**AERONAUTICAL CHARTING FORUM**  
**Instrument Procedures Group**  
**Meeting 16-02 October 25, 2016**

**RECOMMENDATION DOCUMENT**

**FAA Control # 16-02-327**

**Subject:** Arrival Holding Patterns Required for Approach Entry

# **RNAV (GPS) RWY 30** **LAS CRUCES INTL (LRU)**

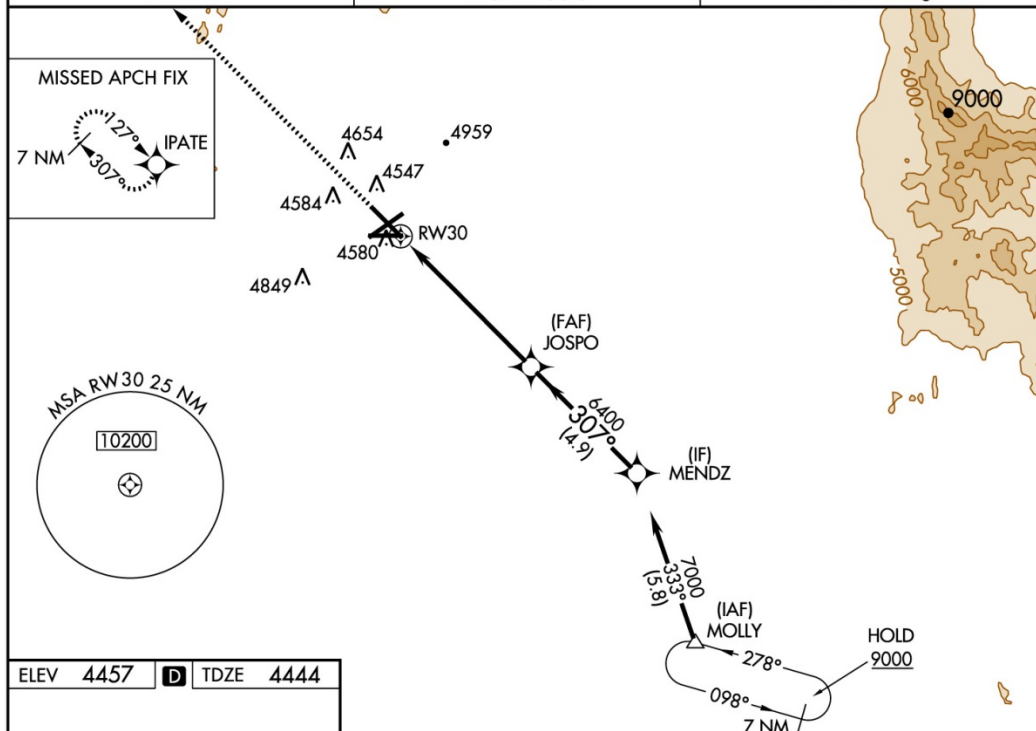
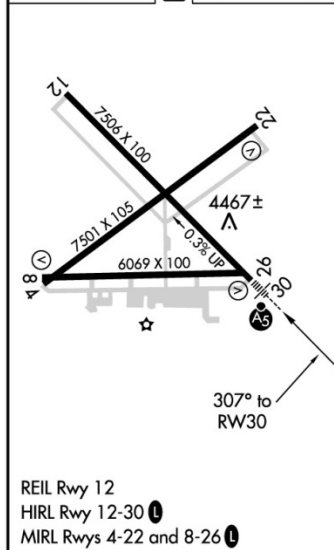
**Background/Discussion:** Recently, two RNAV IAPs were published with an arrival holding pattern that is required for procedure entry. One is a new RNAV Rwy 19R procedure at KRVS (Attachment 1); the other is an amendment of the RNAV Rwy 30 procedure at KLRU (Attachment 2). For reference also attached are the former KLRU RNAV Rwy 30 (Attachment 3) and a snippet of the KLRU en route low-altitude area (Attachment 4).

These are two examples of an arrival holding pattern being a de facto HILPT, which is contrary to the intent of criteria and specifically prohibited by implementation policy in FAA Order 8260.19G. Based on input from NBAA, and follow-up by AFS-420, a NOTAM was issued prohibiting arrival on the KLRU RNAV Rwy 30 from V94 westbound or V611 southeast bound. The NOTAM removes some ambiguity to procedure entry but does not change the fact that the arrival holding pattern at MOLLY is a de facto HILPT. Note also the confusion at KLRU where straight-in on V94 from the west is permitted for the ILS Rwy 30 IAP even when RNAV navigation is used. (Attachment 5).

1. Criteria and policy should be revised to prohibit the use of an arrival holding pattern when a satisfactory HILPT can be placed at the intermediate fix. When that is not possible, then an arrival holding pattern may be used for procedure entry from an airway provided the holding pattern is coded in the nav-database as part of the applicable approach transition and a chart note is published informing the pilot that the arrival hold is mandatory for procedure entry. NBAA proposes the following Planview Note:

“Arrivals at JOXIT on V343 northeast bound, arrival holding for approach entry mandatory” See example in Attachment 6.
